**MTF ERL**

*Comments #122, #123*

**Amphenol Corporation**

**October 13, 2020**

From 3ck contributed TP1-TP4 channels

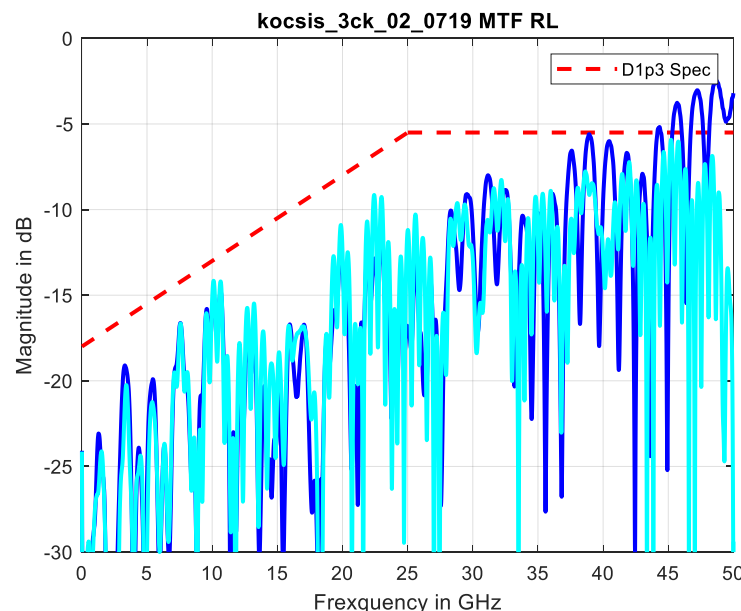
- There is currently only one posted MTF channel

- There have be several changes proposed to the RL mask, specifically at higher frequencies (>35GHz)

- New proposals continue to shape the RL mask around presented data

- There has not been much work to map the RL mask to ERL so to enable consistent expectations between MTF and C2M, CR, and KR

Table ~~1206-1~~

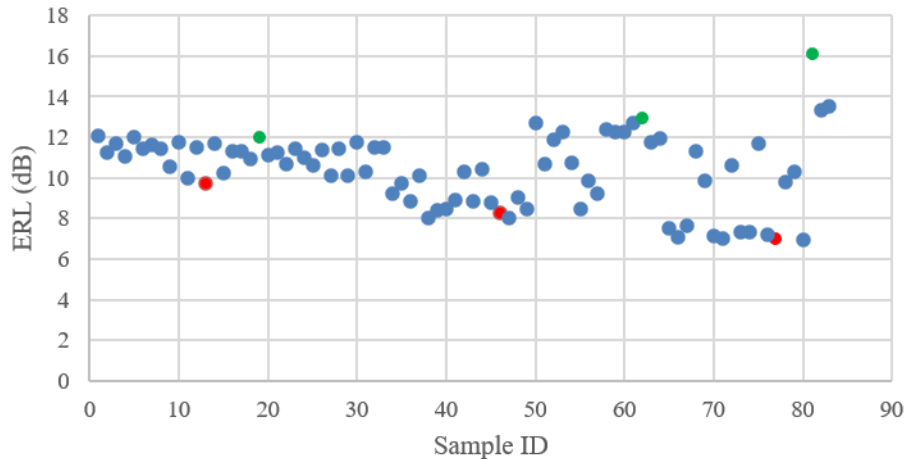
**\*The entire test fixture, between test points will be included in the ERL calculation.**

- The MTF test could leverage settings from a C2M setup with the exception that the entire fixture would be included in the ERL result, including the RF launch

- Keep the limit line defined in Eq. 162B-6 as an informative requirement
- Add MTF ERL to Annex 162B as defined on Slide 6
- Make the normative limit for MTF ERL = 8dB

## Larger Sample Study

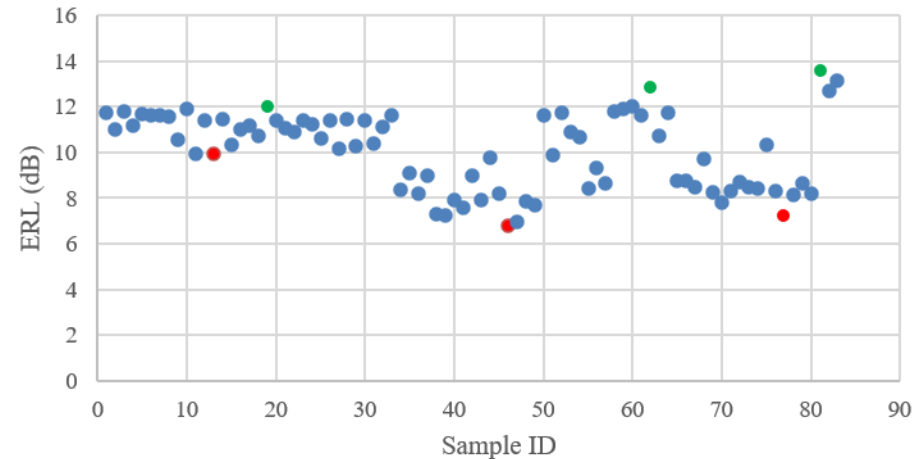
- 83 samples of MTF data were collected and compared using the methodology on the previous slide
- All samples are measured with compliant MCB and HCB
- Some samples are highly “engineered” for lab measurement
  - (3) of the **better** results were chosen for further investigation
  - (3) of the **poorer** results were chosen for further investigation

## Sample Comparison

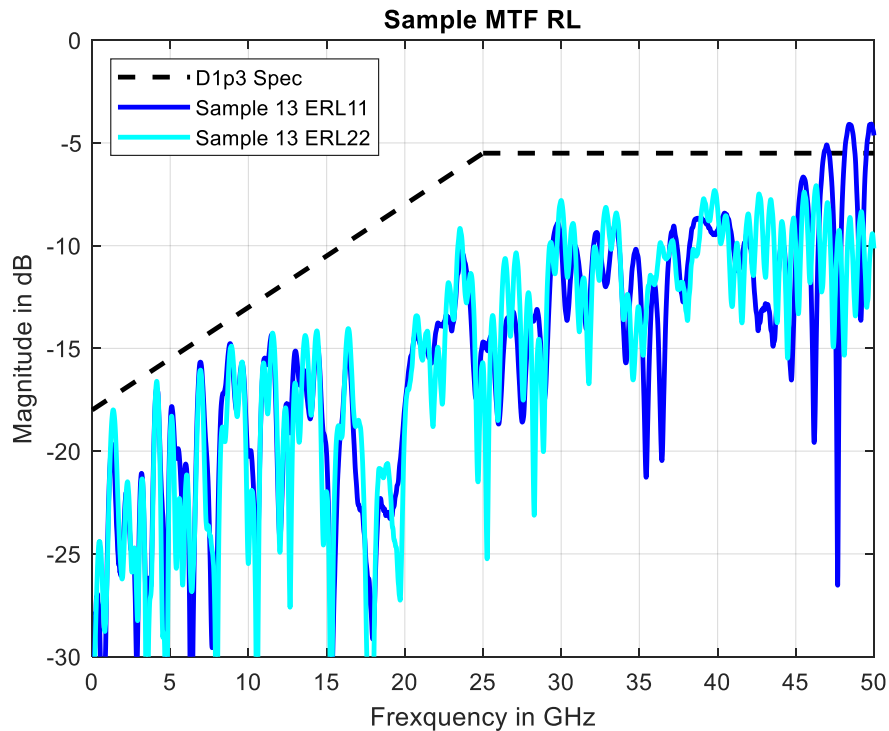
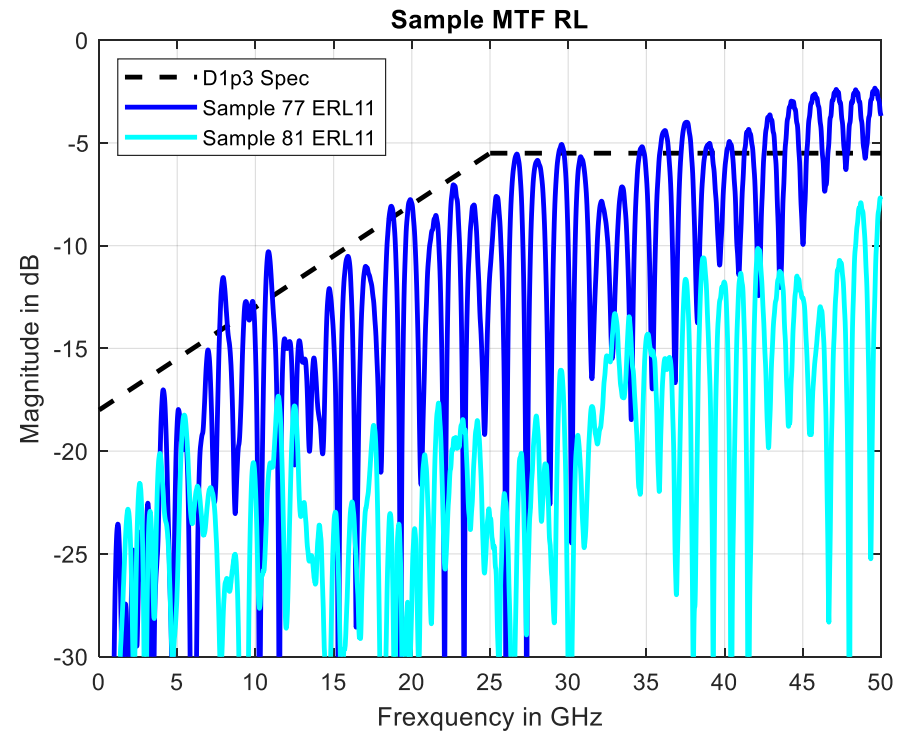
The difference caused by the limit line violation >45GHz is ~0.2dB ERL

The difference between ERL ~7dB  
ERL ~16dB is very significant

## Sample Comparison

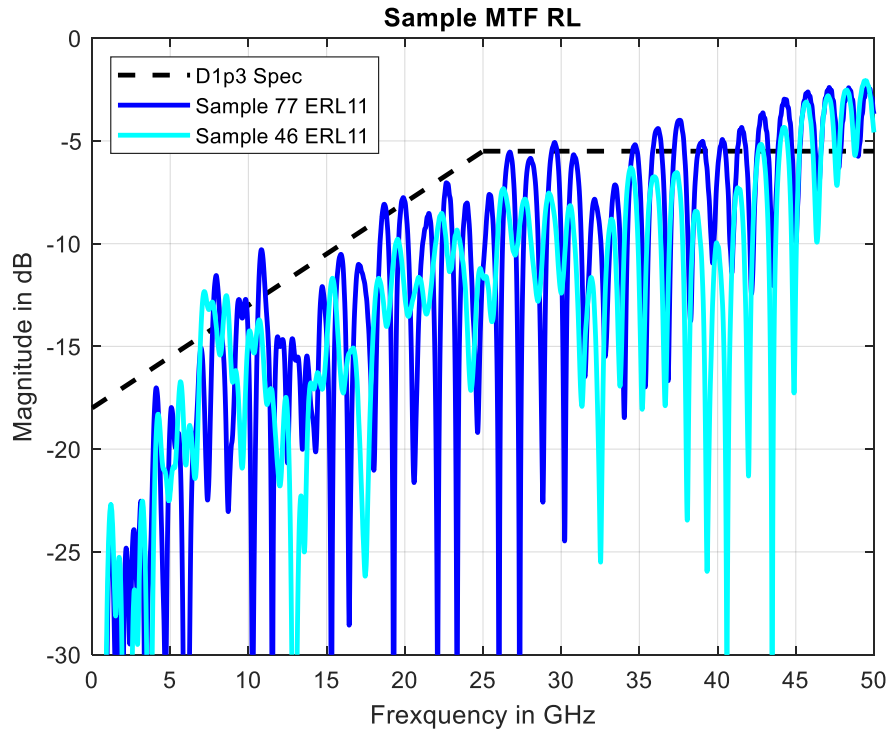
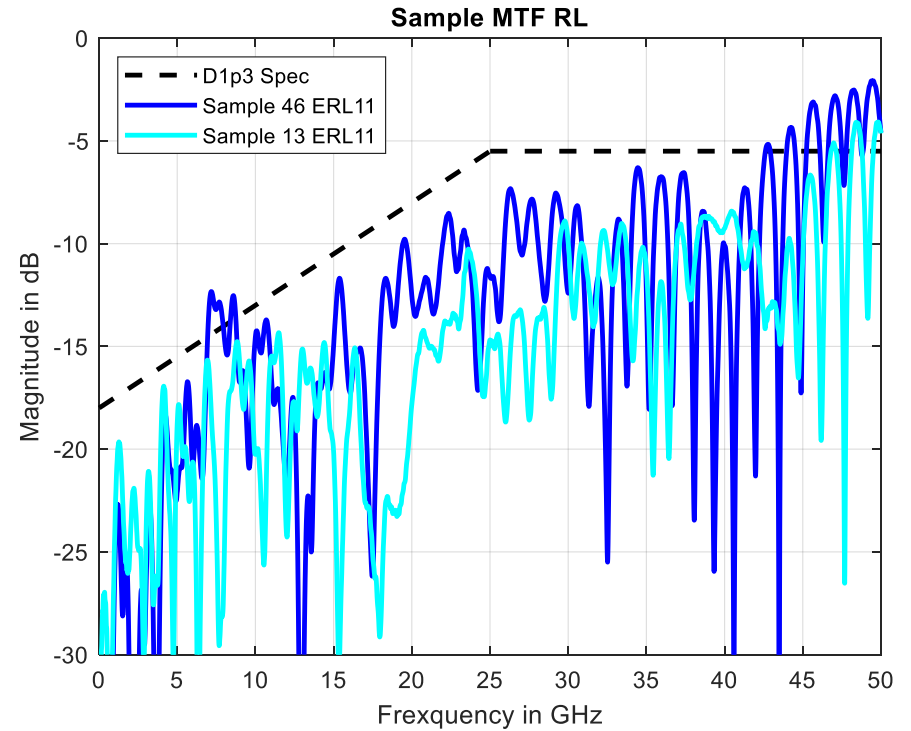
Shown difference between ERL ~7dB and ERL ~8dB

Shown difference between ERL ~8dB and ERL ~10dB
